Zen Wind Energy Facility near Saron in the Western Cape Province

Motivation for amendment of Environmental Authorisation

DEA Ref.: 14/12/16/3/3/2/322

November 2019

Figure 5.1: Wind turbines comparative layouts above sensitivity habitat mapping (Source: Calidris).

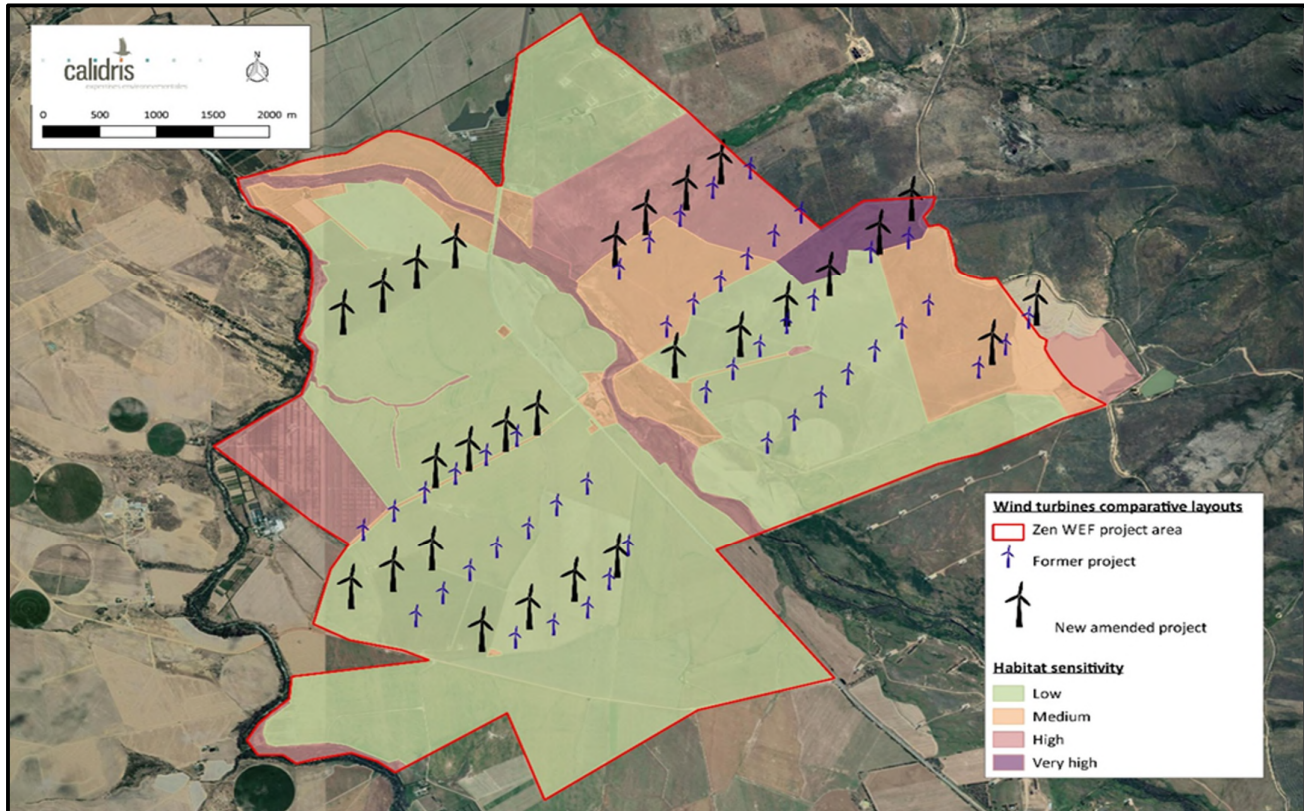
In order to reduce the impact of a windfarm, one of the main factors to take into account is the location (BIRDLIFE INTERNATIONAL, 2018). The overall area used for the authorised project and the amended layout is fairly the same as the authorized layout, with the difference being the density of turbines and the location of each of these turbines. When considering the habitat sensitivity mapping below compiled by Calidris, and based on the 2019 spring surveys, west of the R44, habitats are mainly occupied by crops like wheat, resulting in a Low sensitivity rating.

Overall, it is unlikely that the amendments to the turbine dimensions, number and layout proposed at Zen Wind Energy Facility would result in significant change in impacts. The amendments will impact species differently, depending on their ecology and behaviour. The results of 2019 surveys indicated that the overall impact is expected to be reduced.

Figure 5.2: Comparative wind turbines layouts above sensitive features mapping (A3 map provided within Appendix J)

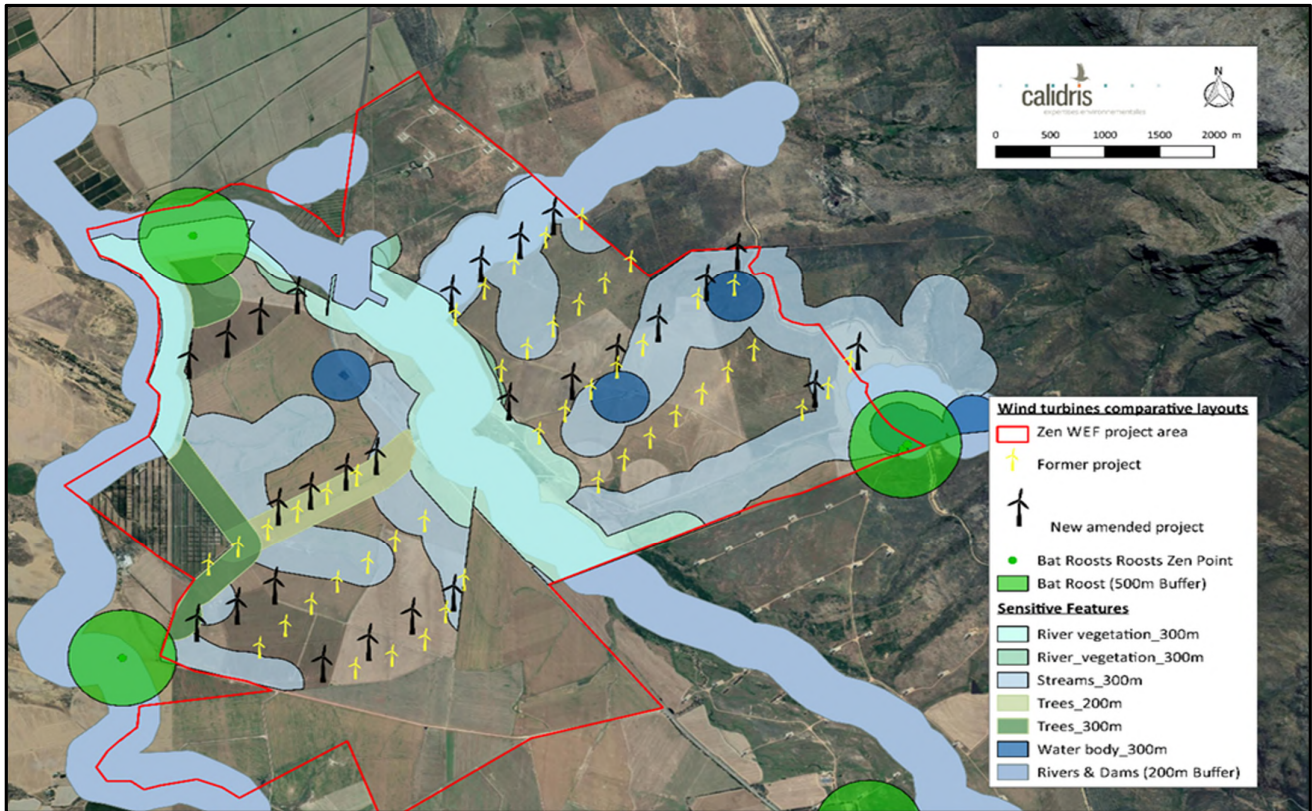
Figure (5.2) below indicated that with the new layout, turbines are farther from sensitive zones or in a smaller number. According to the analysis of bat activity and environmental features by Bio3 and the results of the ongoing monitoring, sensitive areas for bat communities should be avoided or modified as little as possible,

As per Figure 5.2. below it can be seen that the amended layout achieves this there are now a fewer number of turbines located outside the designated buffer zones and sensitive features.

Figure 5.3: Viewshed analysis represents the potential total visual exposure of the original turbine dimensions (illustrated in blue) compared to the proposed new turbine dimensions and locations (illustrated in pink).

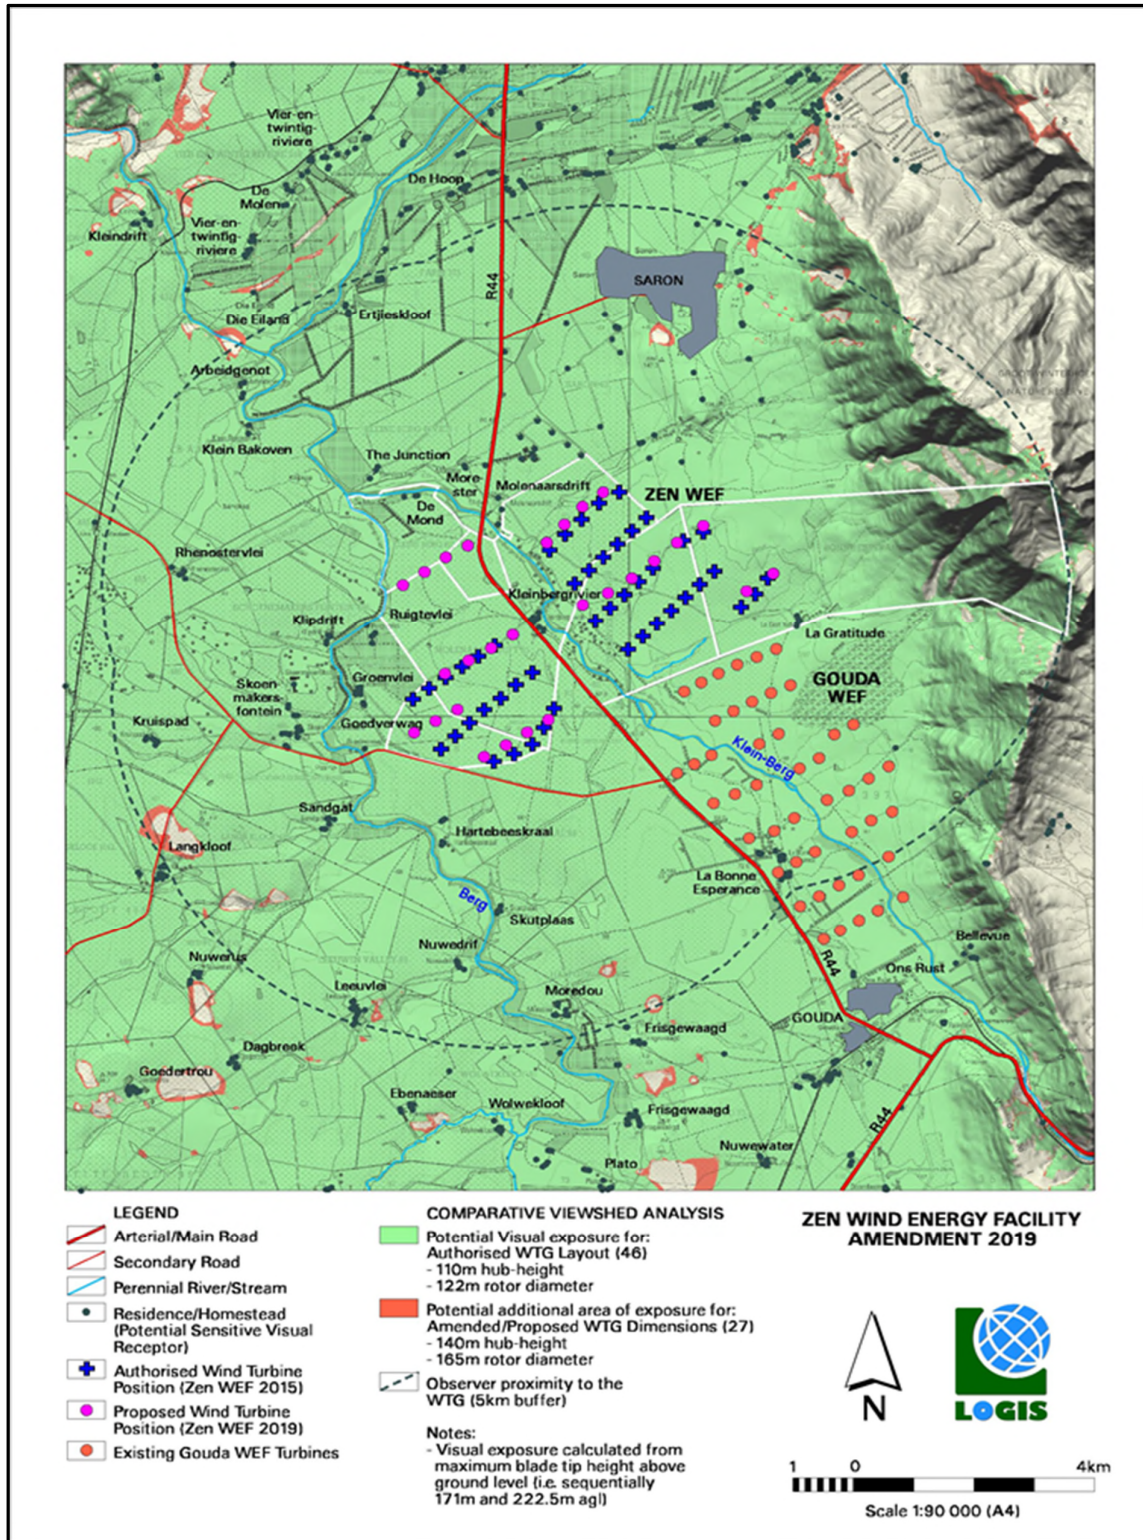
A visibility analysis was undertaken from each of the originally authorised wind turbine positions (46 in total) at an offset of 171m (maximum blade tip height) above ground level to indicate the potential total visual exposure of the original turbine dimensions and at an offset of 222.5m to indicate the visual exposure of the increased turbine dimensions and reduced number of turbines (27 in total). The results of the visibility analyses are displayed in Figure 5.3 (refer to the specialist report contained in Appendix C).

No additional sensitive visual receptors are located within the area of increased visual exposure. The increased area of visual exposure does not include any additional exposure to major roads within the study area. The location of La Gratitude, Kleinbergrievier and La Bonne Esperance on properties earmarked for existing or potential wind energy facility developments reduces the probability of this impact occurring. The residential (built-up) nature of the town is expected to contain the visual impact to acceptable levels. Where homesteads are derelict or deserted, the visual impact will be non-existent, until such time as it is inhabited again. It is therefore expected that the wind turbine structures, both the original dimensions and the proposed increased dimensions and taking into consideration the reduction in the number of turbines, would be equally visible and noticeable from both the roads and homesteads.

Figure 5.7.1: Zen WEF project infrastructure (new proposed layout) superimposed on DAFF land capability raster data (data source: DAFF 2017)(A3 Map available within Appendix J)

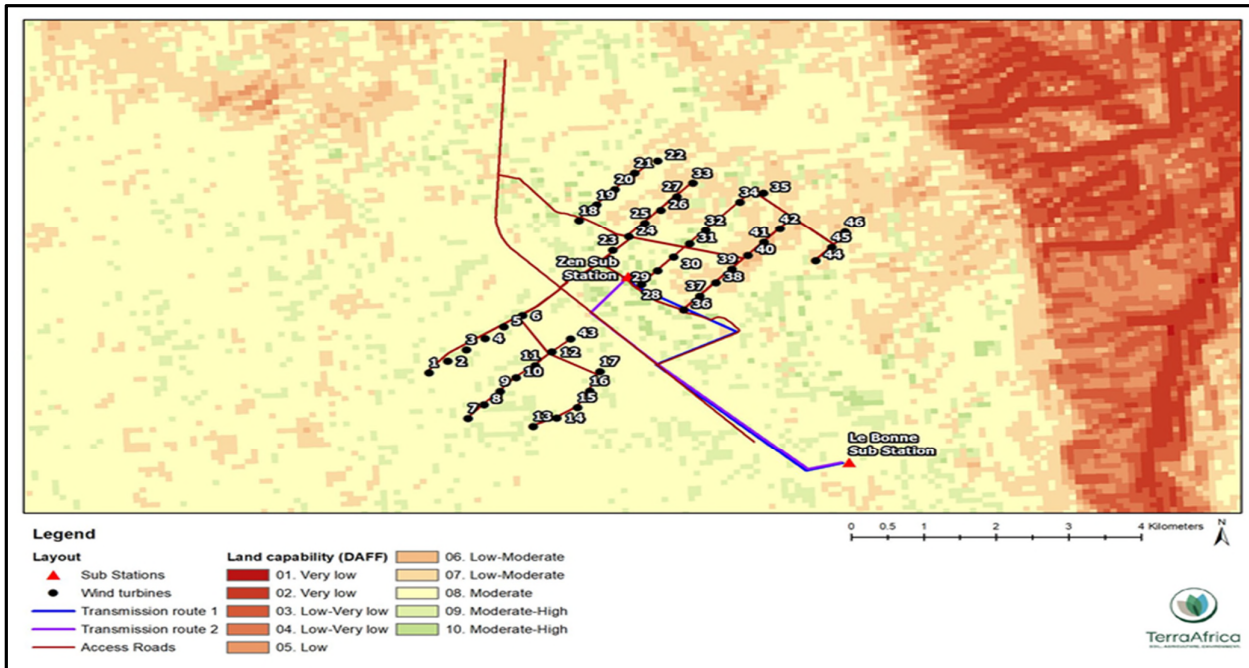
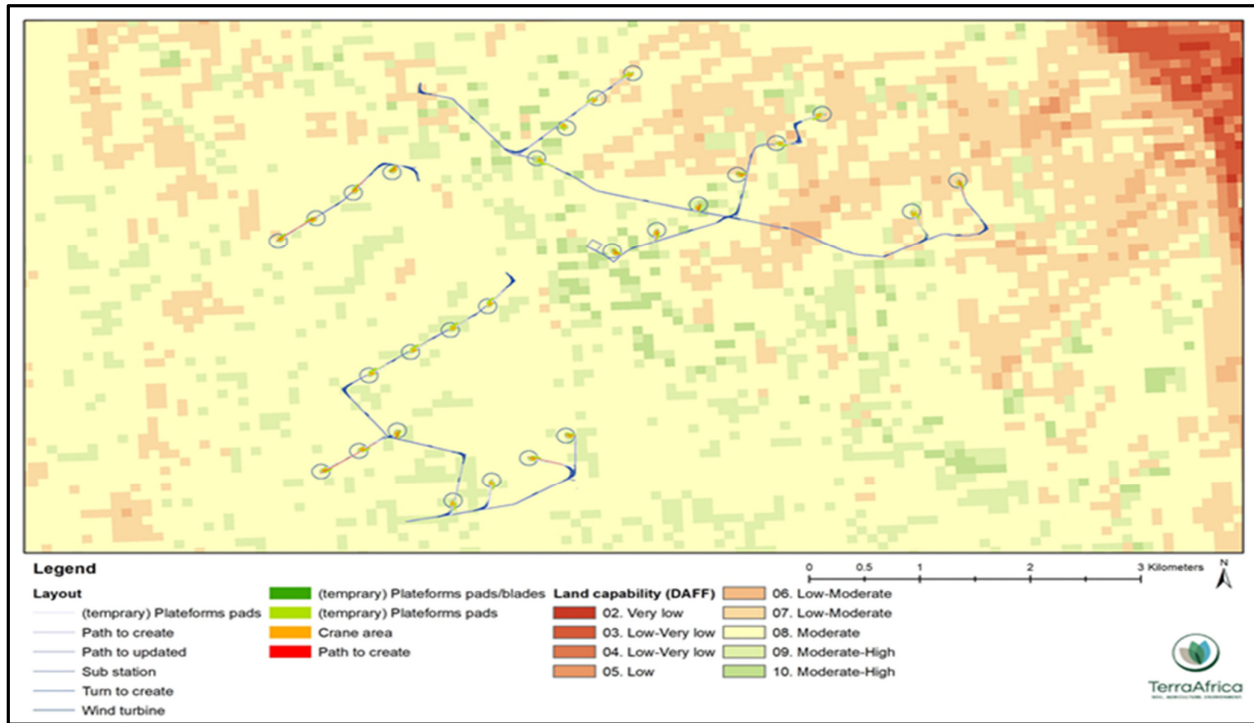
Figure 5.7 and Figure 5.7.1 indicate both project layouts fall on land with a varying degree of land capabilities ranging from Low-Very Low (Class 4) to Moderate-High (Class 10). Higher land capability classes are associated with the middle and south-western parts of the proposed project areas. Following the land capability analysis, it was concluded that the two project layouts are located on land with a similar range of land capabilities. The slightly wider range of land capabilities associated with the initial project layout is due to the fact that it was spread over a larger area.

In addition, the crane and foundation areas that are planned in areas of high sensitivity have been reduced from 5,47ha to 3,13ha. Apart from the reduction in areas impacted upon, the new project layout aimed to position the turbines along existing roads in order to avoid crop fields as far as possible. This is an important design measure to ensure that crop field tillage can continue uninterrupted as far as possible.

Figure 5.8.1: . The amended layout for the Zen Wind Energy Facility, showing the new 27 turbine layout of the facility.

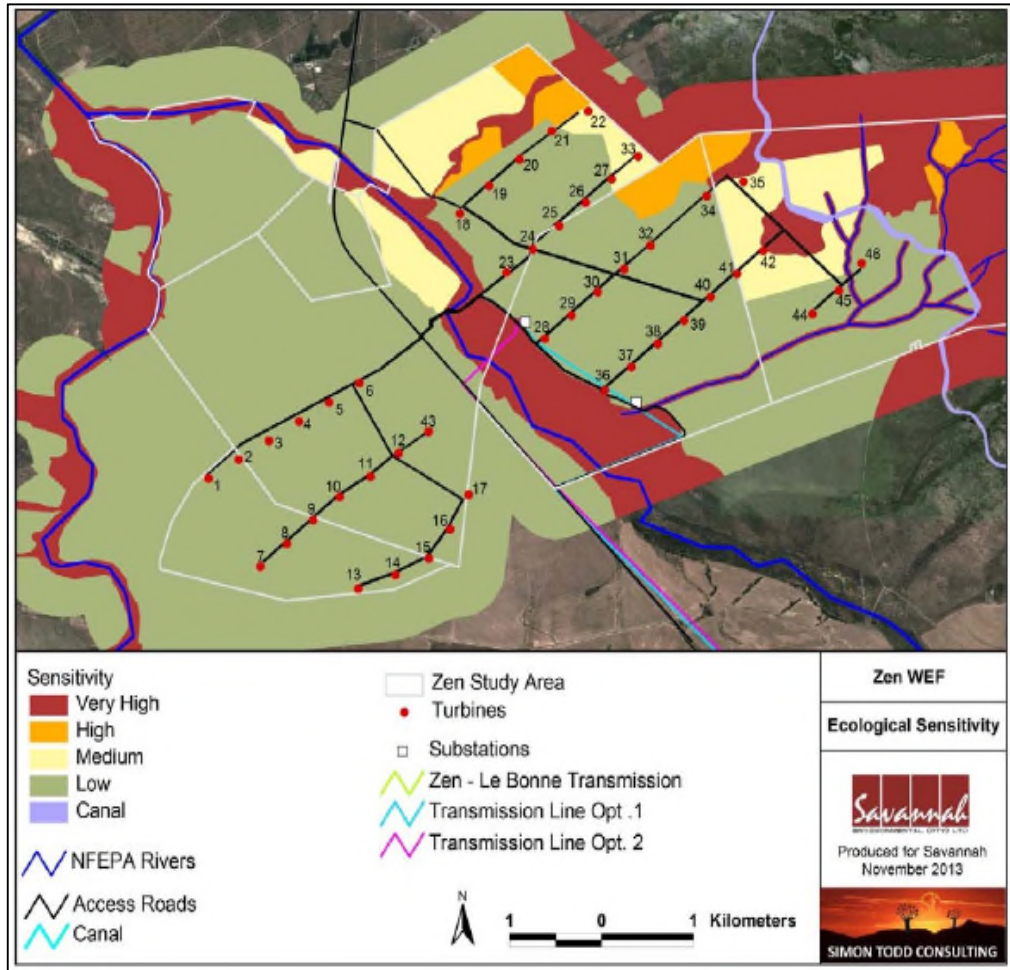
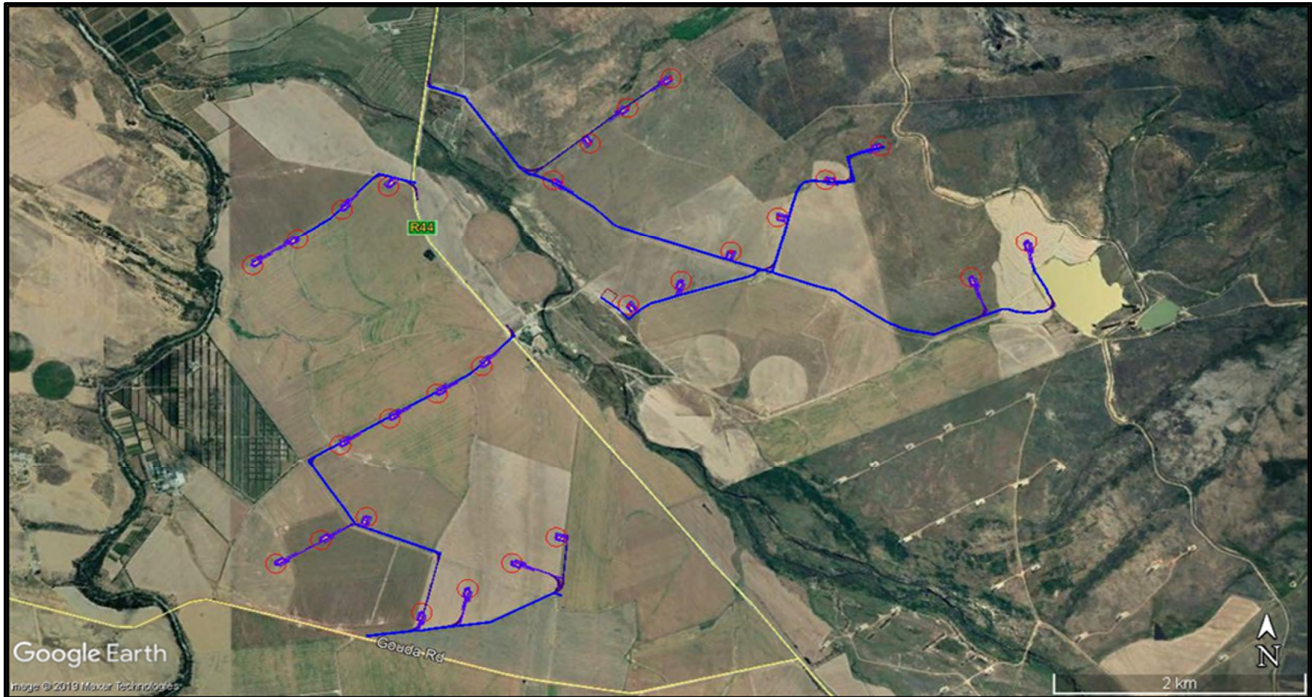
The amended layout remains within the low sensitivity parts of the site and as a result, there are no impacts that have increased as a result of the amendment. Consequently, there are no impacts associated with the proposed changes to the layout that would increase terrestrial ecological impacts as compared to those originally assessed.
